OPINION

Preliminary Plan 1-89193
NAME OF PLAN: MILLERS ADDITION TO BETHESDA

SUBJECT: Stormwater Management Concept Plan
Preliminary Plan # 1-89193, MILLER'S ADDN TO BETHESDA, PAR C
Subdivision Review Committee Meeting of 8/7/1989

MINUTES
SUBDIVISION REVIEW COMMITTEE
MEETING OF AUGUST 7, 1989

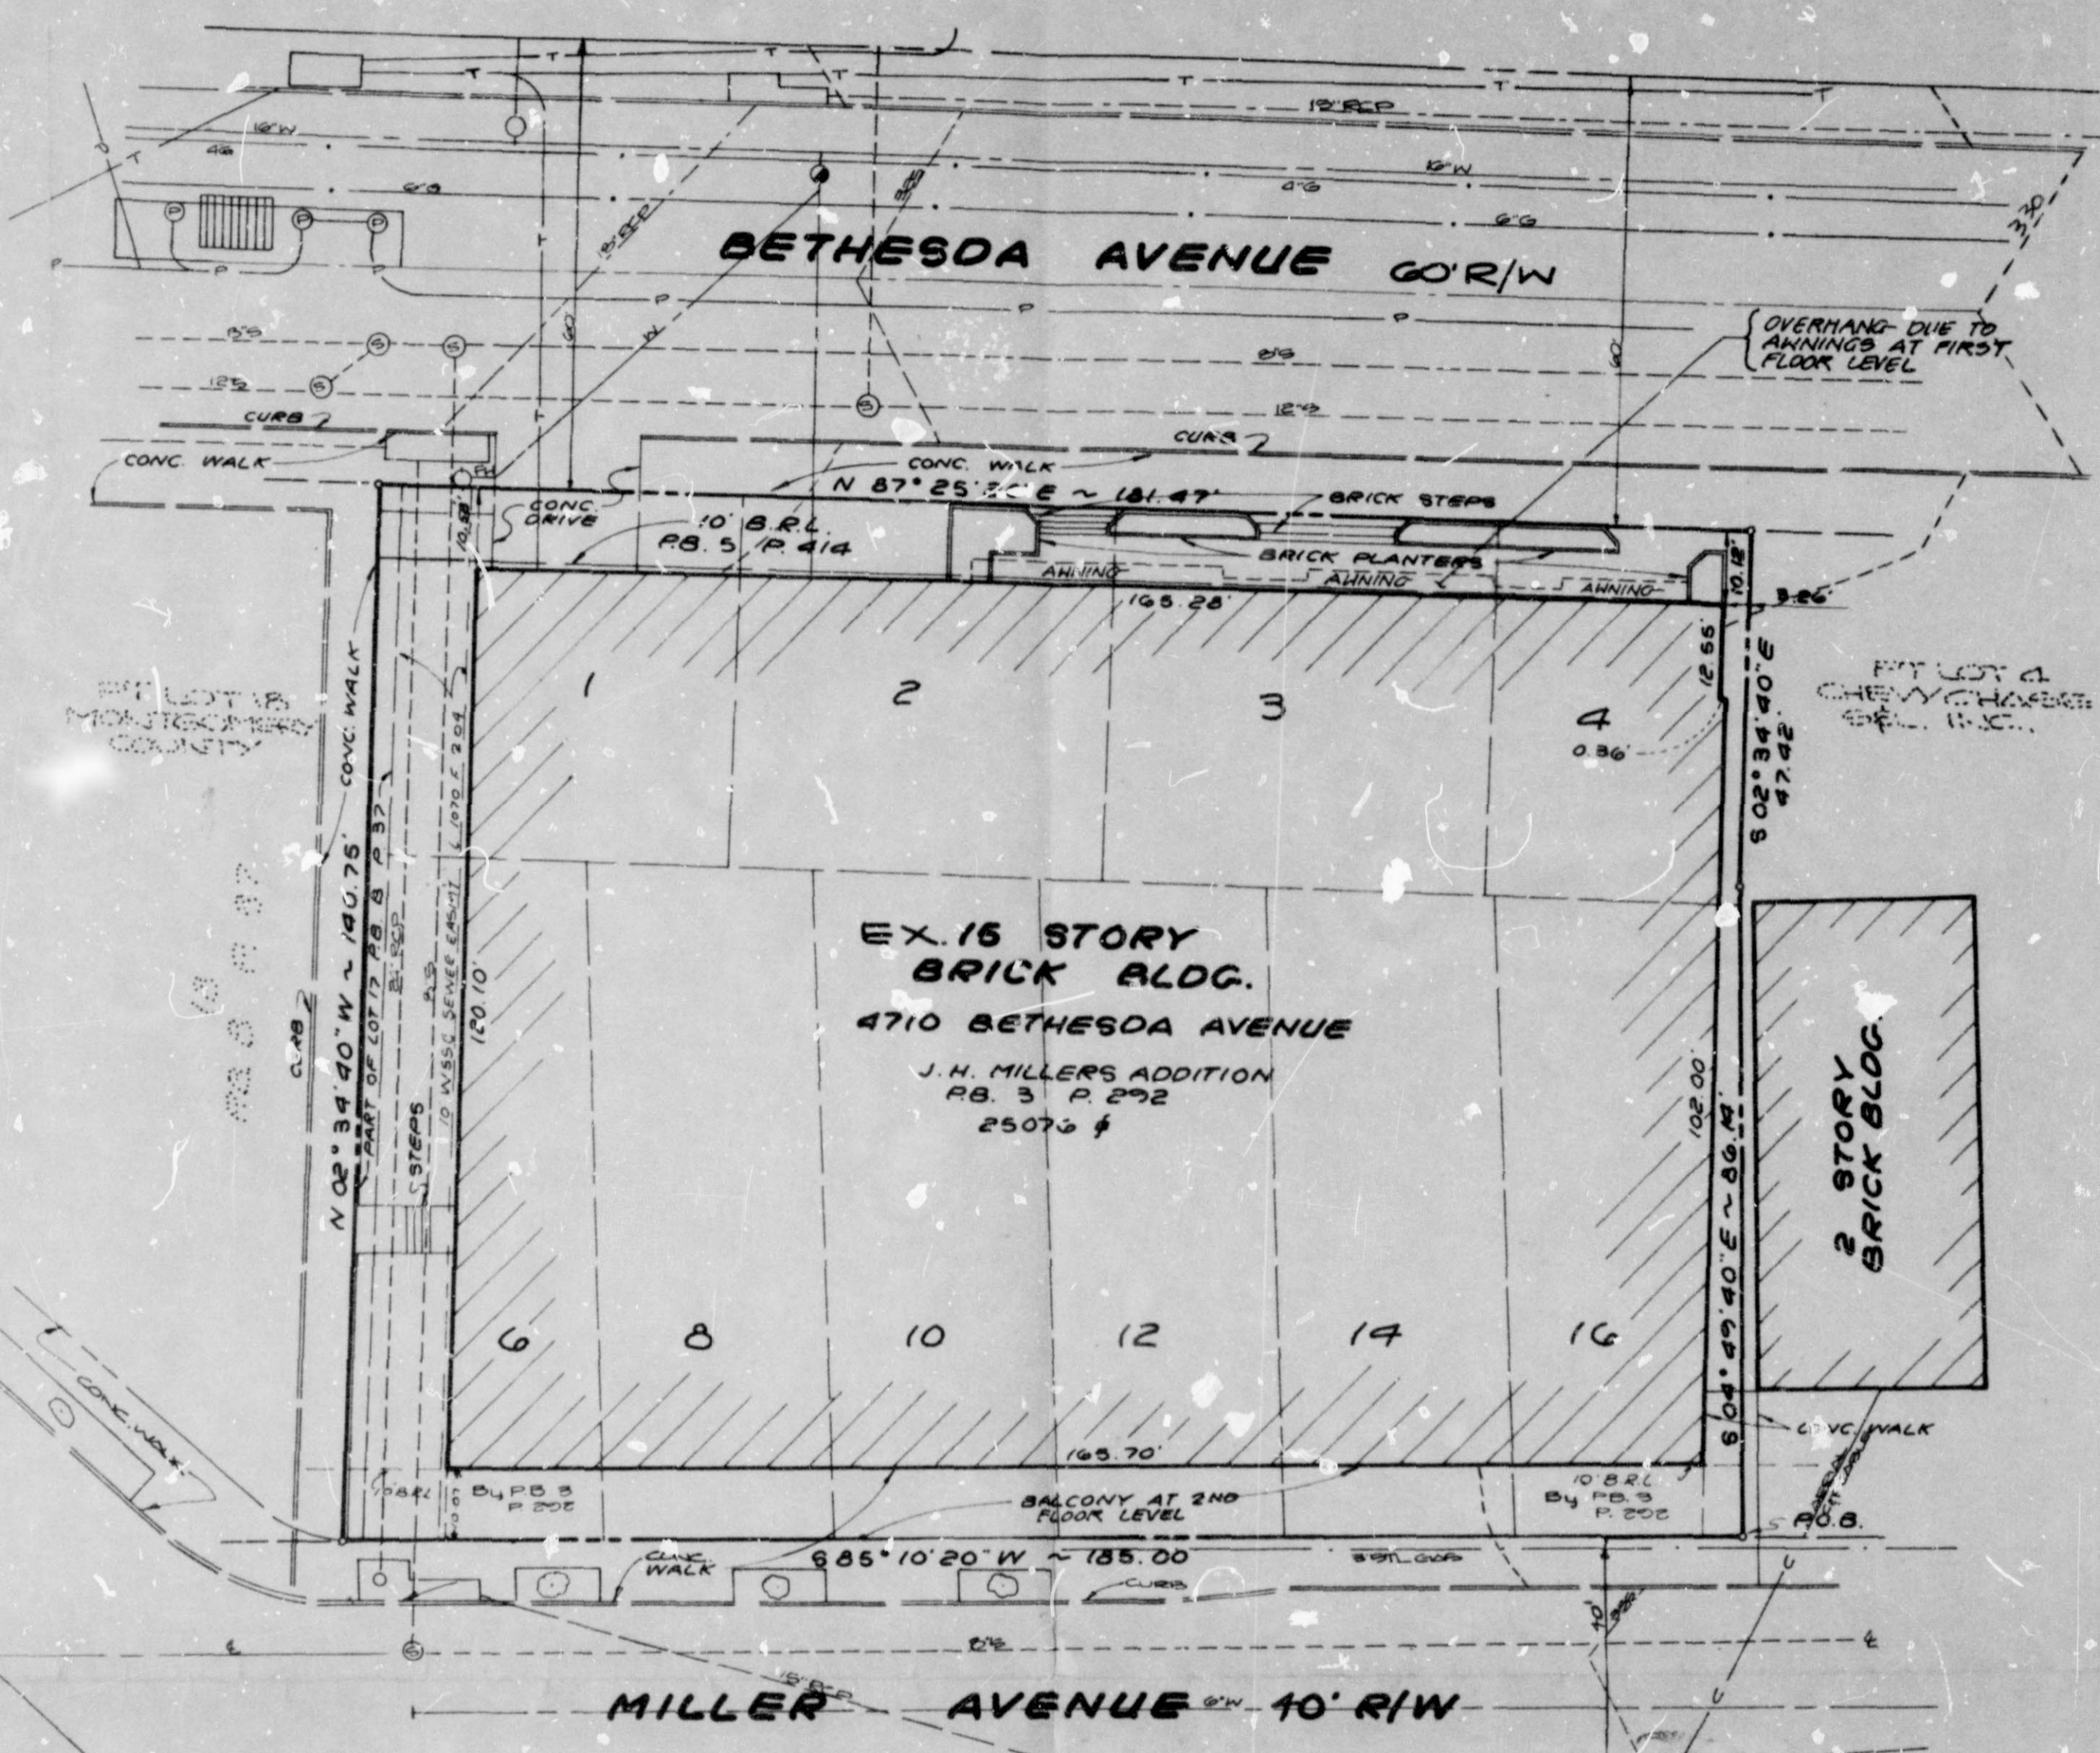
- Limit any additional floor area to 4,700 sq ft, per Beth. CBD Sector Plan.

- Dedicate 45 feet from the center line of pavement on Miller Avenue
- Dedicate 30 feet from the center line of pavement on Bethesda Avenue

1. Limit use to existing; supply statement for file
2. Need covenant for future widening of Miller Ave. 45' off opposite side
3. Bethesda Avenue requires 60' dedication
4. Stormwater management exempt
5. Application complete

1. Necessary slope and drainage easements. Slope easements are to be as determined by study or to the building restriction line.
2. Submit storm drainage and/or flood plain studies with computations, based on proposed plan. Limit of flood plain and building restriction line to be shown on the plat where applicable. Flood plain is to be dimensioned from property lines.
3. Necessary dedication for future widening of Bethesda Avenue in accordance with the master plan.
4. Covenant for Miller Avenue dedication & construction.
5. Permanent monuments and property line markers, as required by Section 50-24(e), are certified on the record plat.
